Appendix A: Request for Variance

Infrastructure Standards for Telecommunications Spaces v4.0

Request Date:	9/12/24
Government POC:	Tim Stark
Org Represented:	Castle Point VA Medical Center
Email Address:	Timothy.Stark@va.gov
Contact Phone:	914-776-4654
Site, Building #, Room, Mission of the Facility Where Requested (also note admin vs medical specific use):	Castle Point VA Medical Center B.15E - TR 011A & TR 315 B.16 - TR F100 B.17 - TR G-203 B.18 - TR 39
Variance Requested:	B.15E & B.15H - TR 011A serves both Buildings 15E and 15H. While technically separate buildings, 15E/H share corridors and exterior walls. There is ample coverage provided from a single TR serving both buildings. B.15E & B.15H - TR 315 serves attic. There is limited programming space on the 4th floor (attic); 3rd floor TR has sufficient capacity to serve any anticipated service needs in the attic. B.16 - TR F100 serves 2nd and 3rd floors. There is limited space available on the 2nd and 3rds floors due to programming needs. It is anticipated that ~75-100 ports are needed for the 1st, 2nd, and 3rd floors combined, which can be served appropriately from a single rack in F100. B.17 - TR G-203 serves the 2nd and 3

1 LEVEL 03 - FLOOR PLAN
1/16" = 1'-0"

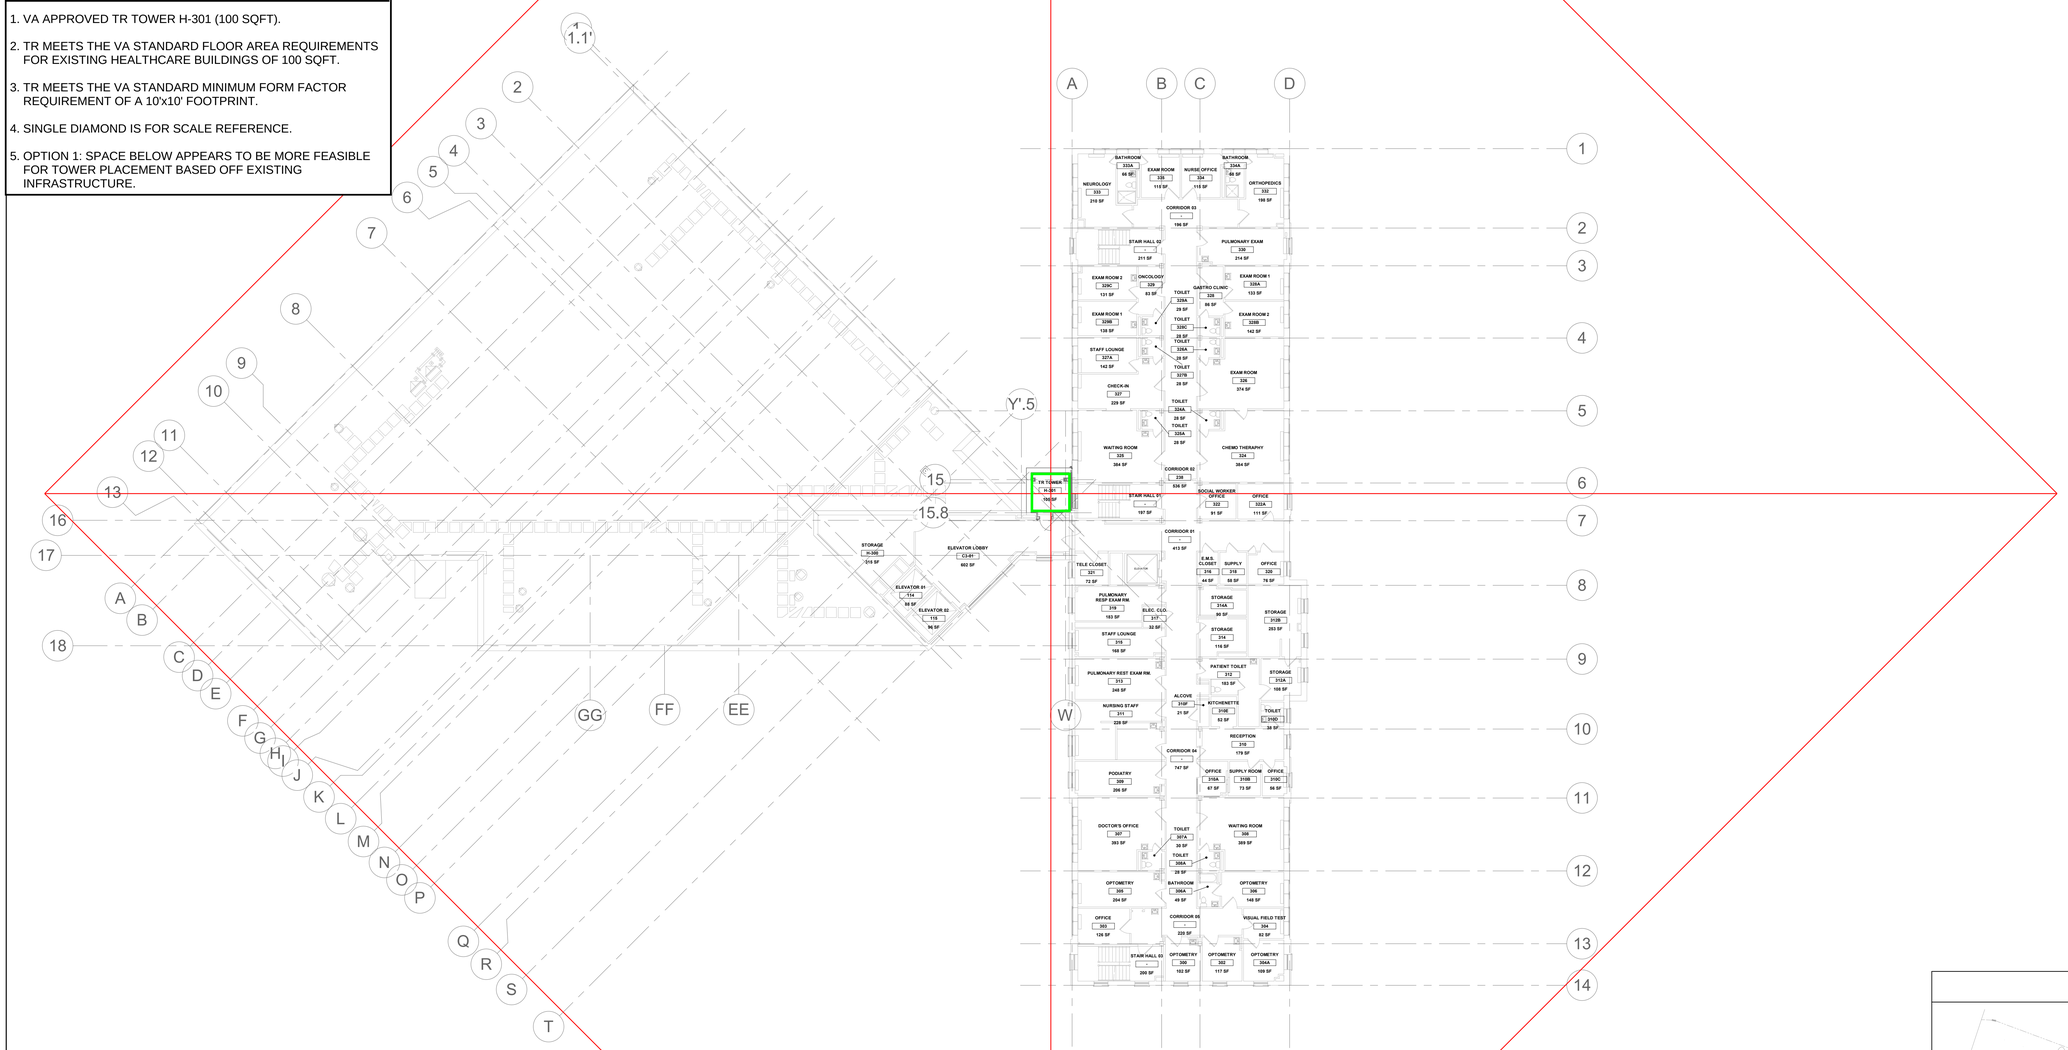
1. VA APPROVED TR TOWER H-301 (100 SQFT).
2. TR MEETS THE VA STANDARD FLOOR AREA REQUIREMENTS FOR EXISTING HEALTHCARE BUILDINGS OF 100 SQFT.
3. TR MEETS THE VA STANDARD MINIMUM FORM FACTOR REQUIREMENT OF A 10'x10' FOOTPRINT.
4. SINGLE DIAMOND IS FOR SCALE REFERENCE.
5. OPTION 1: SPACE BELOW APPEARS TO BE MORE FEASIBLE FOR TOWER PLACEMENT BASED OFF EXISTING INFRASTRUCTURE.

1 LEVEL 04 - FLOOR PLAN

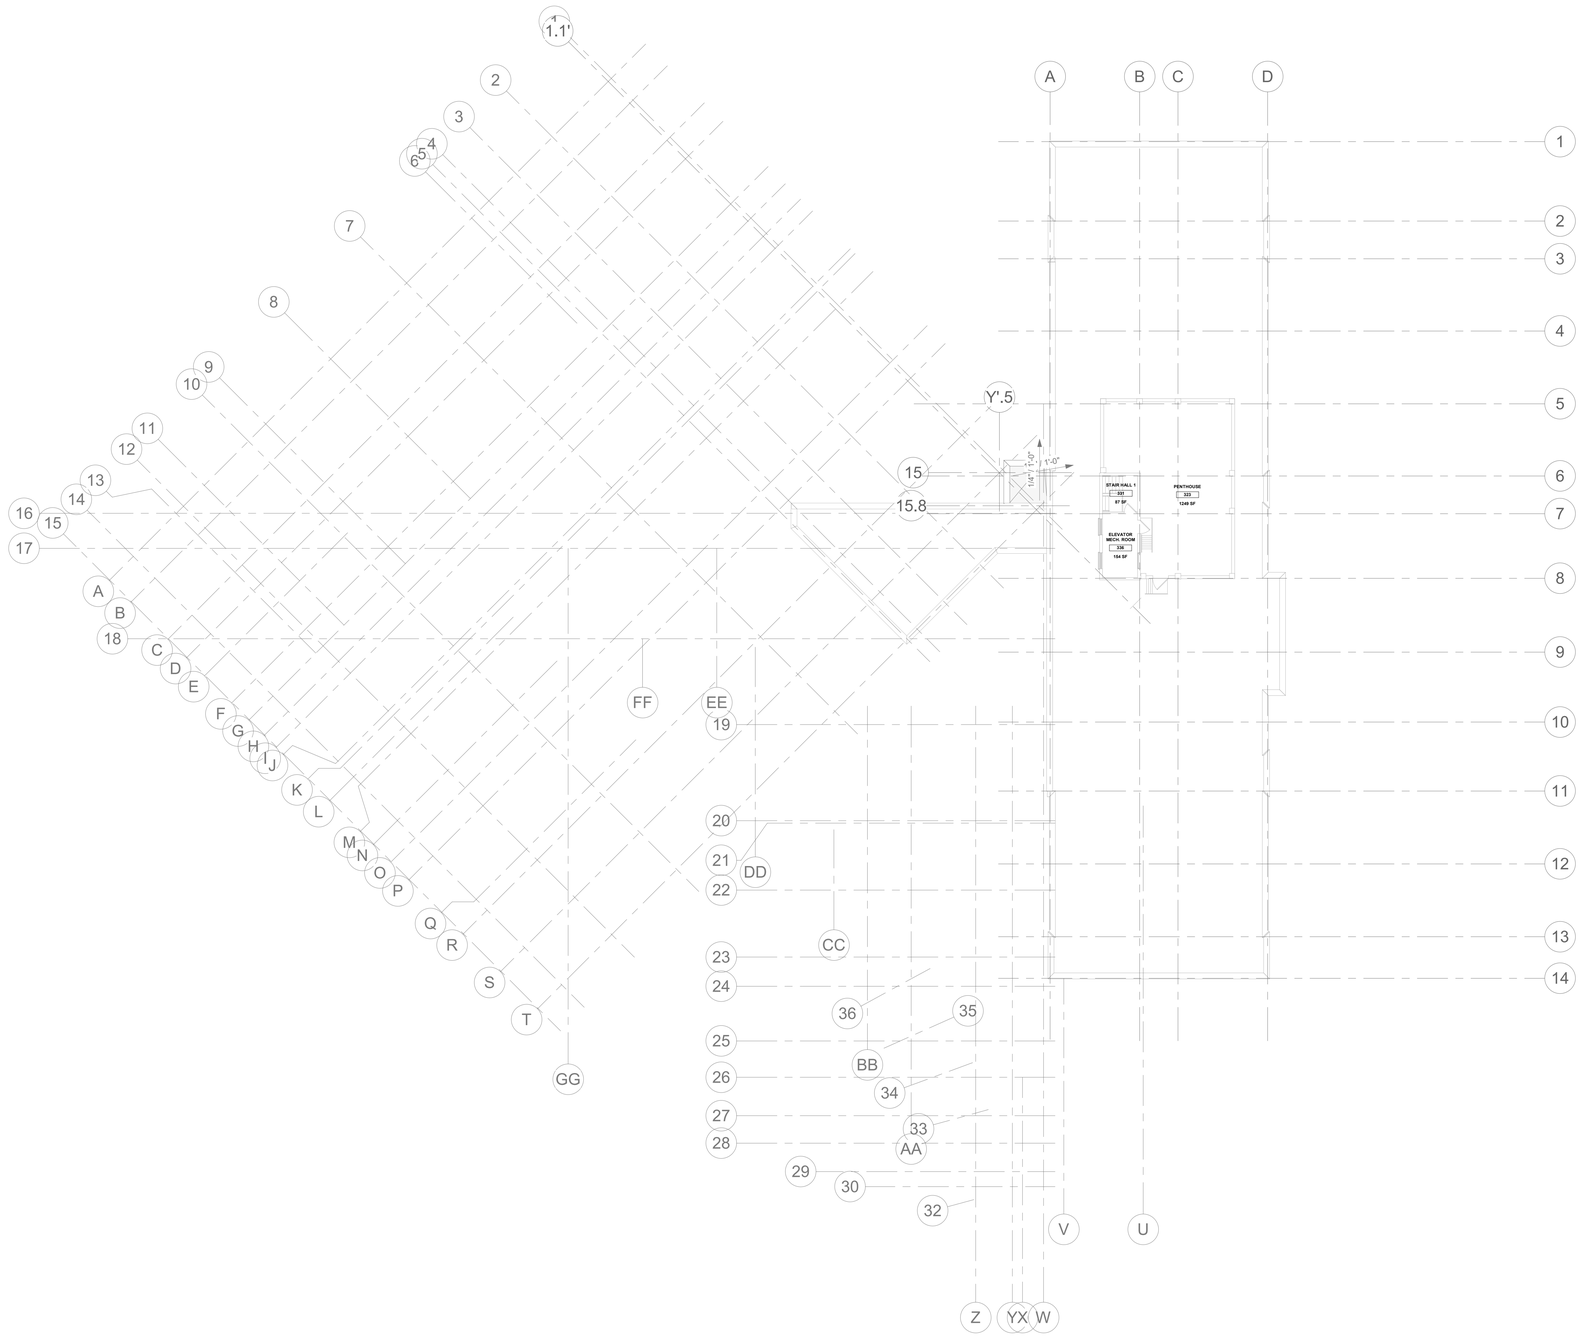
BLDG 15E & 15H - LEVEL 04
1. PENTHOUSE CURRENTLY HAS NO PROGRAMMING NEEDS; ANY PROGRAMMING NEEDS WILL BE MET FROM TR TOWER T-3 ON LEVEL 03.

1 LEVEL 01 - FLOOR PLAN
1/8" = 1'-0"

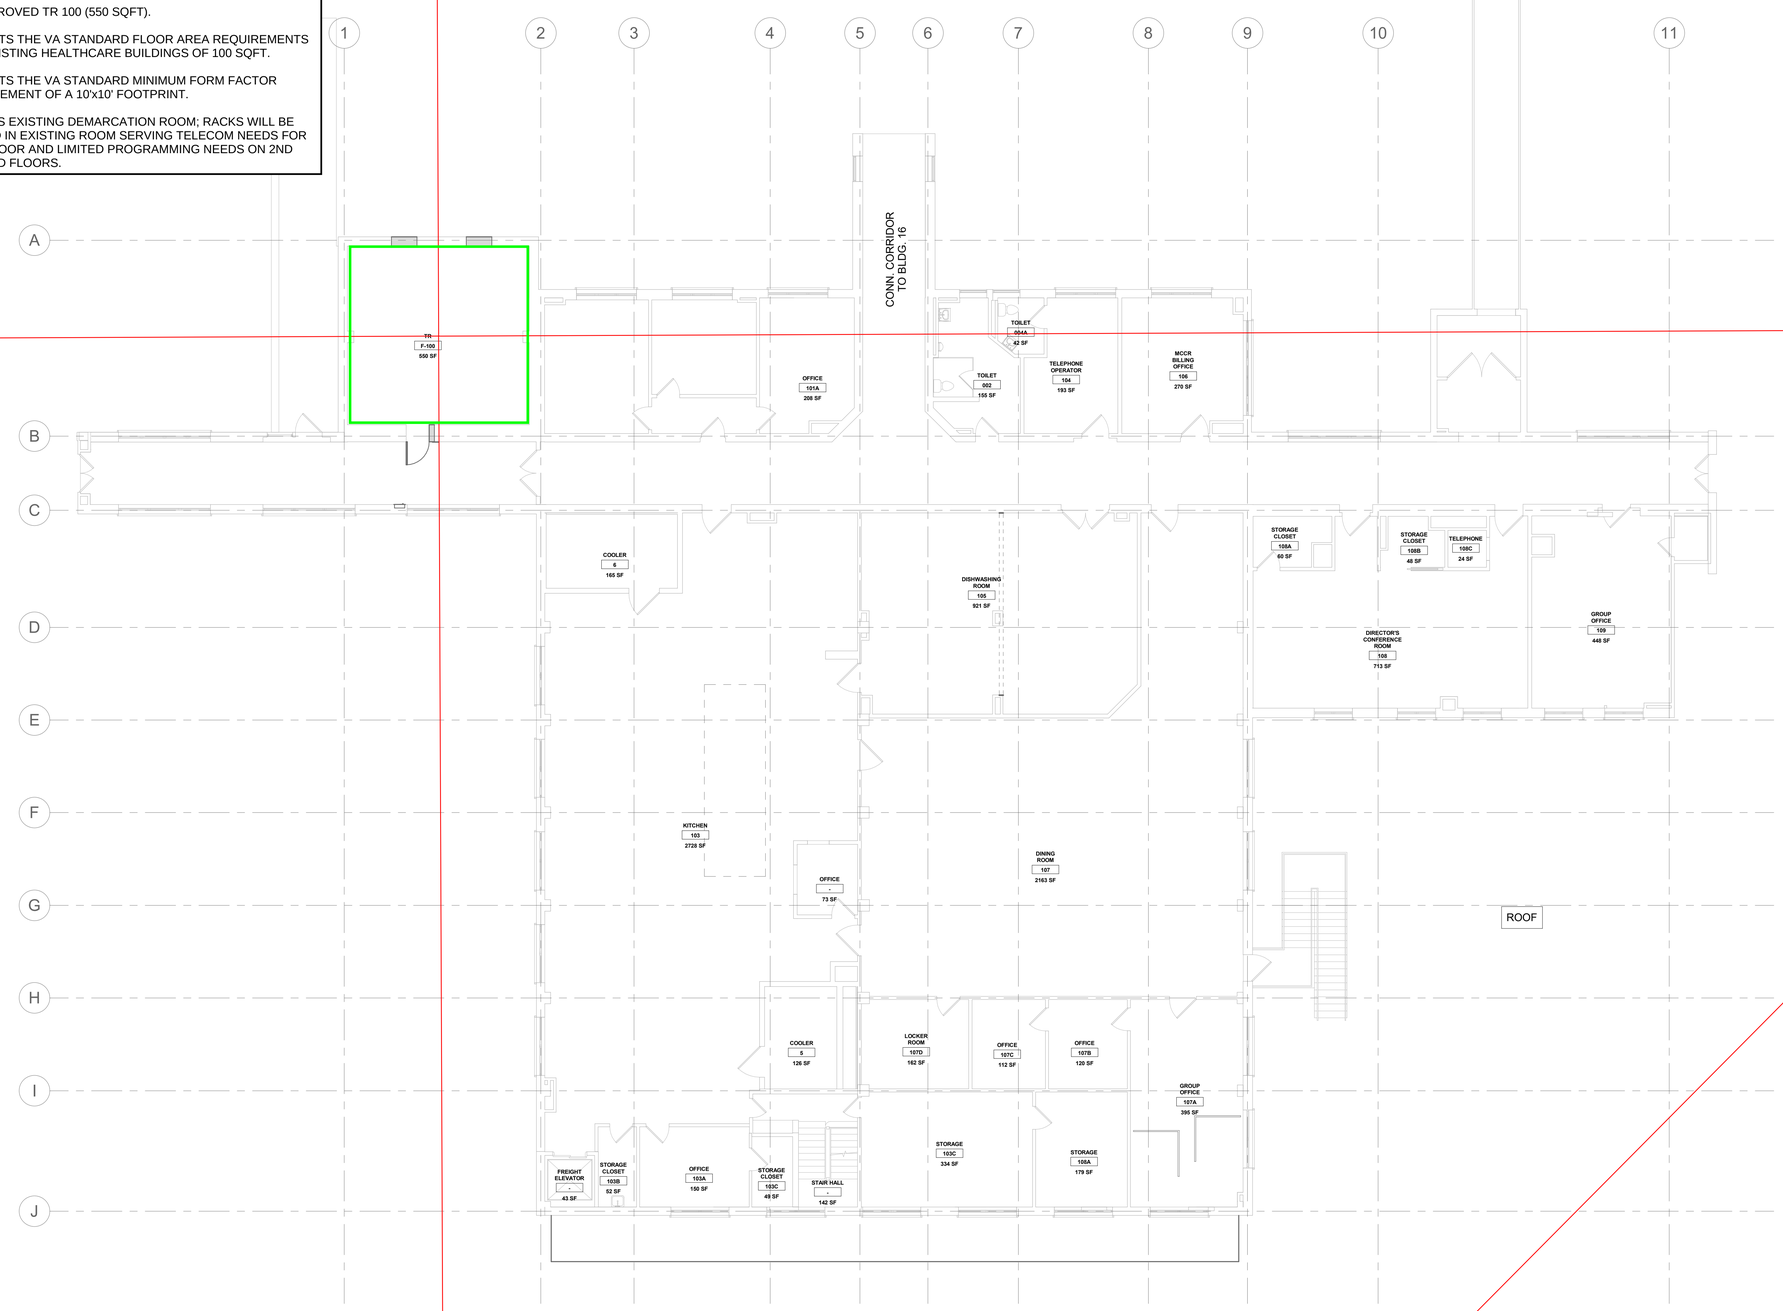
1. VA APPROVED TR 100 (550 SQFT).
2. TR MEETS THE VA STANDARD FLOOR AREA REQUIREMENTS FOR EXISTING HEALTHCARE BUILDINGS OF 100 SQFT.
3. TR MEETS THE VA STANDARD MINIMUM FORM FACTOR REQUIREMENT OF A 10'x10' FOOTPRINT.
4. ROOM IS EXISTING DEMARCATION ROOM; RACKS WILL BE PLACED IN EXISTING ROOM SERVING TELECOM NEEDS FOR THIS FLOOR AND LIMITED PROGRAMMING NEEDS ON 2ND AND 3RD FLOORS.

1 LEVEL 02 - FLOOR PLAN

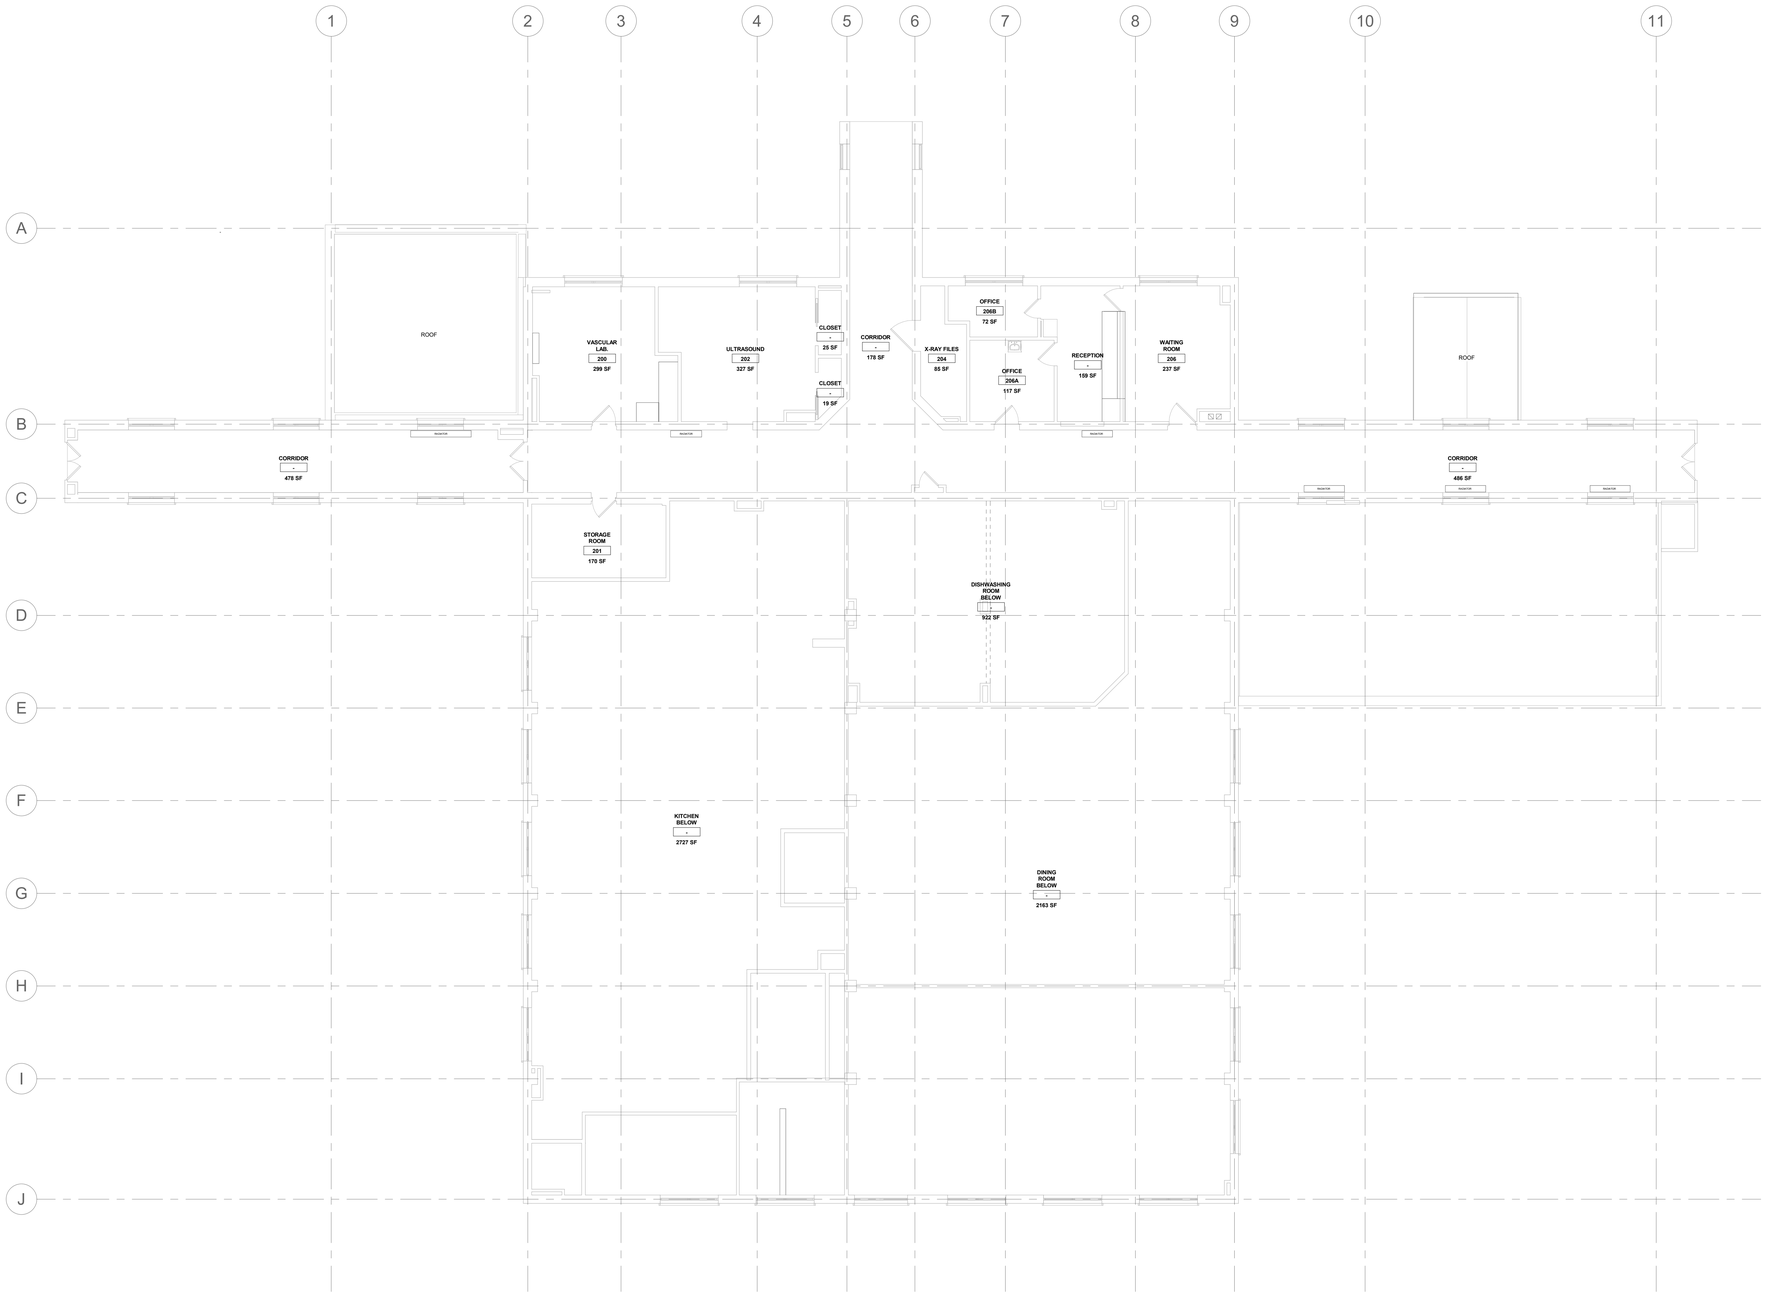
BLDG 16 - LEVEL 02
1. LIMITED PROGRAMMING NEEDS ON THIS FLOOR WILL BE SERVICED FROM TR 100 ON LEVEL 01.
